REQUEST FOR TECHNICAL REVISION (TR) COVER SHEET

File No.: M- 1982-086 Site Name: Fairplay Site

MINING PLAN MAP

Permit # M-1982-086

Figure 3

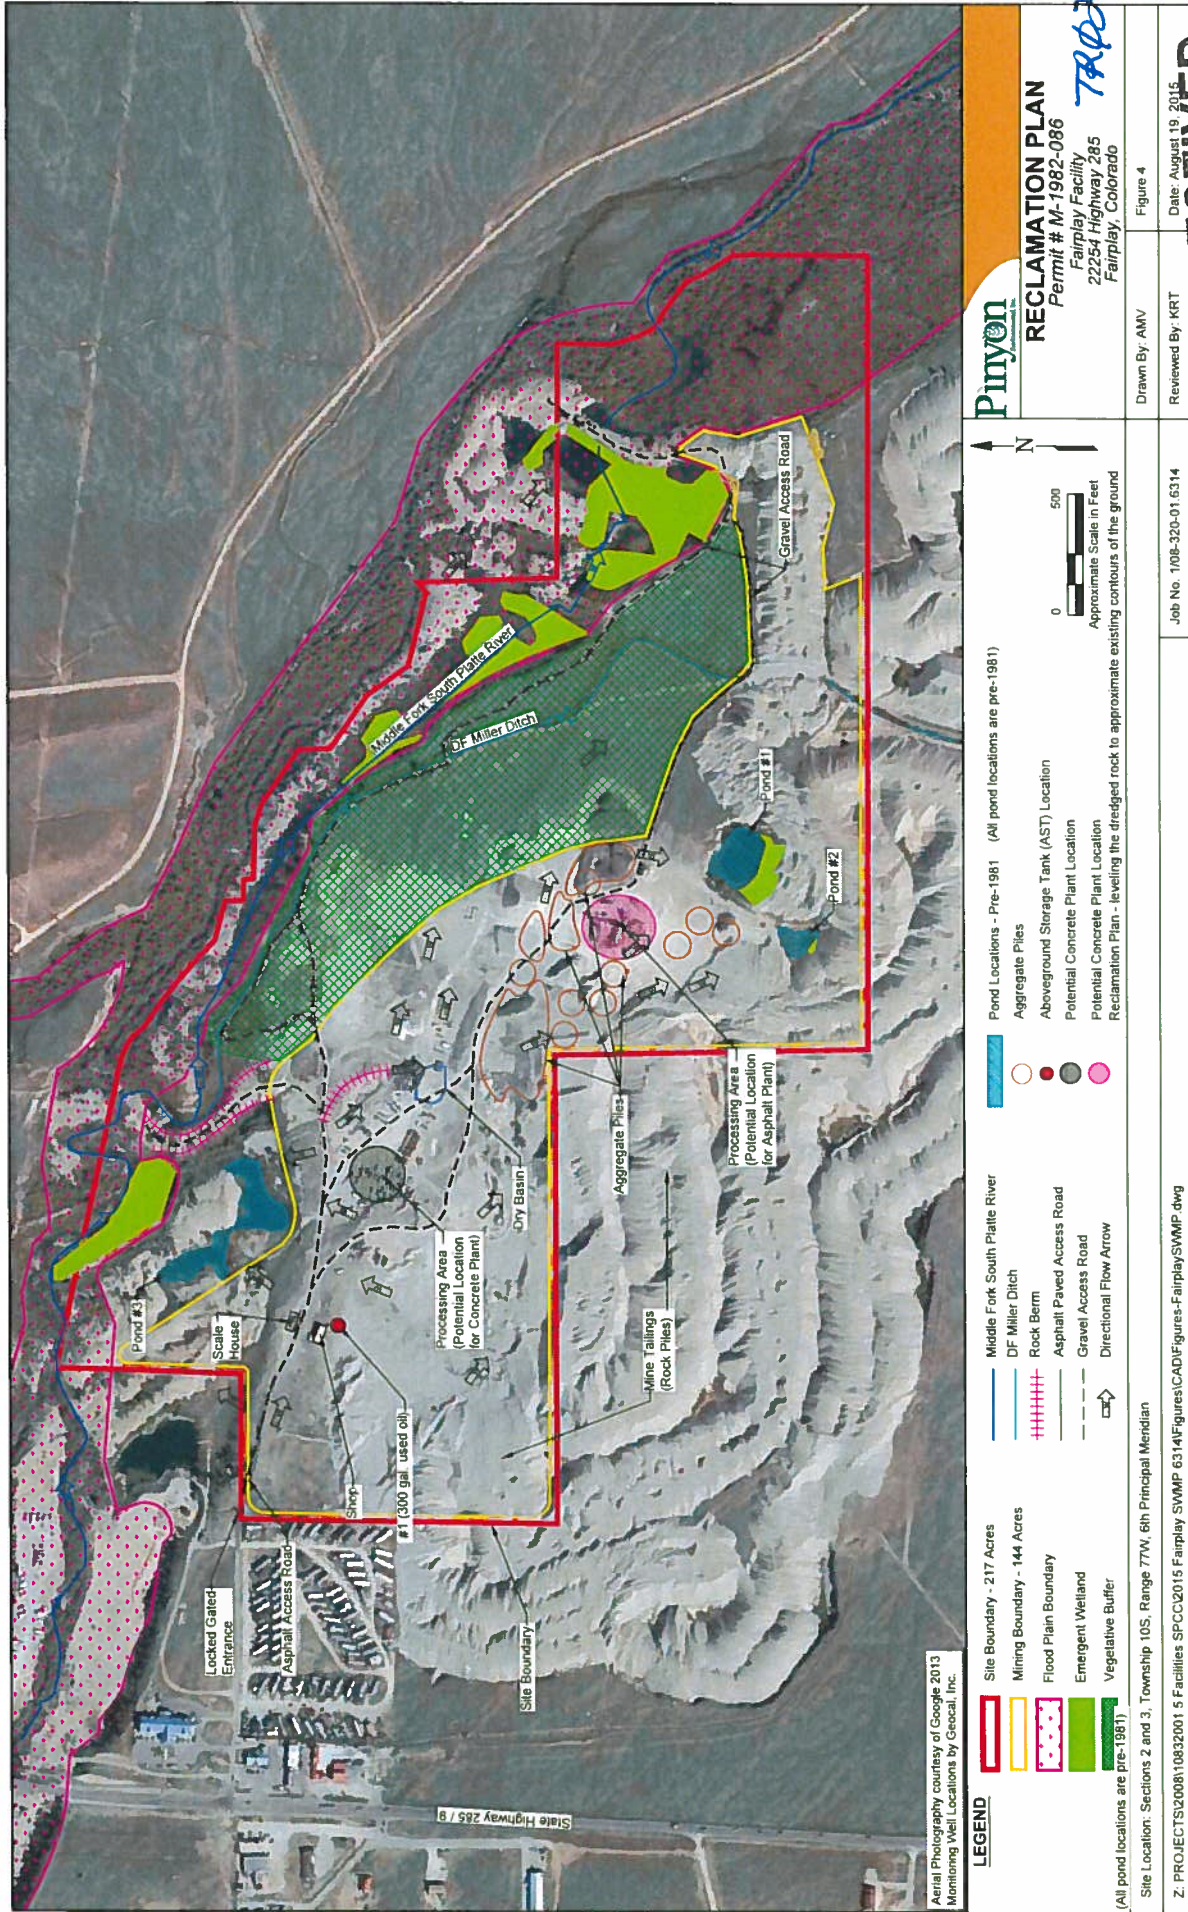
This is not a change in the permit. However, it is updating the Mining Plan map. Ponds on site are pre-1981.

We are also updating the Reclamation Plan leveling the dredged rock to the approximate existing contours of the ground.
